Watts Bar Nuclear Plant, Unit 1
Facility Operating License No. NPF-90
NRC Docket No. 50-390

Subject: **Watts Bar Nuclear Plant – Two-Unit Offsite Dose Calculation Manual, Revision 0**

Change Document Summary - Watts Bar Nuclear Plant Two-Unit Offsite Dose Calculation Manual, Revision 0

Watts Bar Nuclear Plant - Two-Unit Offsite Dose Calculation Manual (ODCM), Revision 0

Figure 9.2 - REMP LOCATIONS FROM ONE TO FIVE MILES FROM THE PLANT

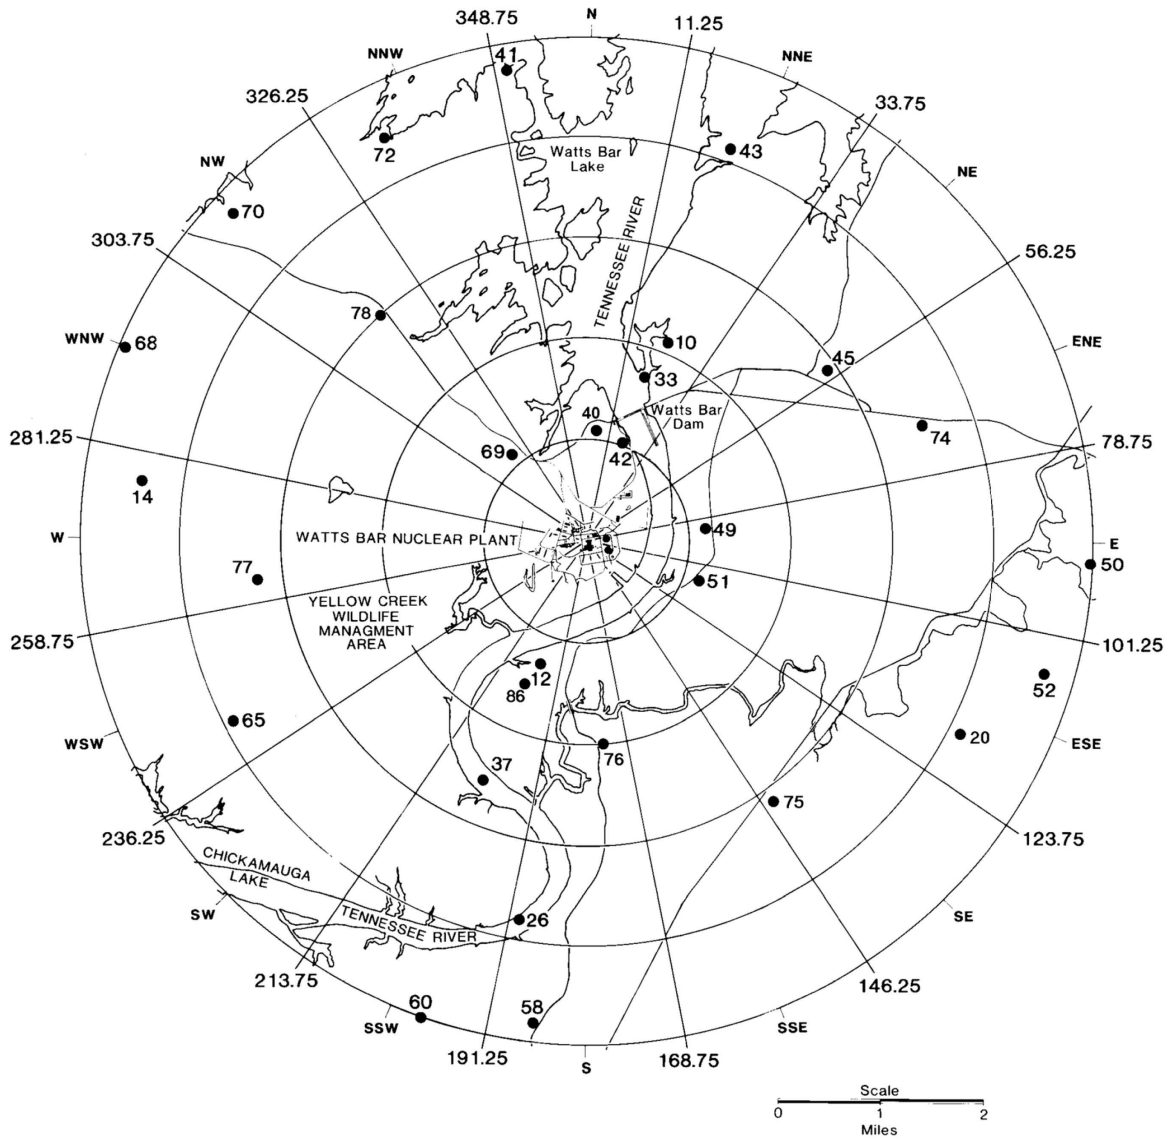
172	182	Figure 9.2 – REMP Locations From One to Five Miles From the Plant	Removed location 27 TRM 529.3 (already included in Figure 9.1) and added location 87 Farm BB.
173	183	Figure 9.3 – REMP Locations Greater Than Five Miles From the Plant	Removed location 22 Farm EH (no more milk cows).
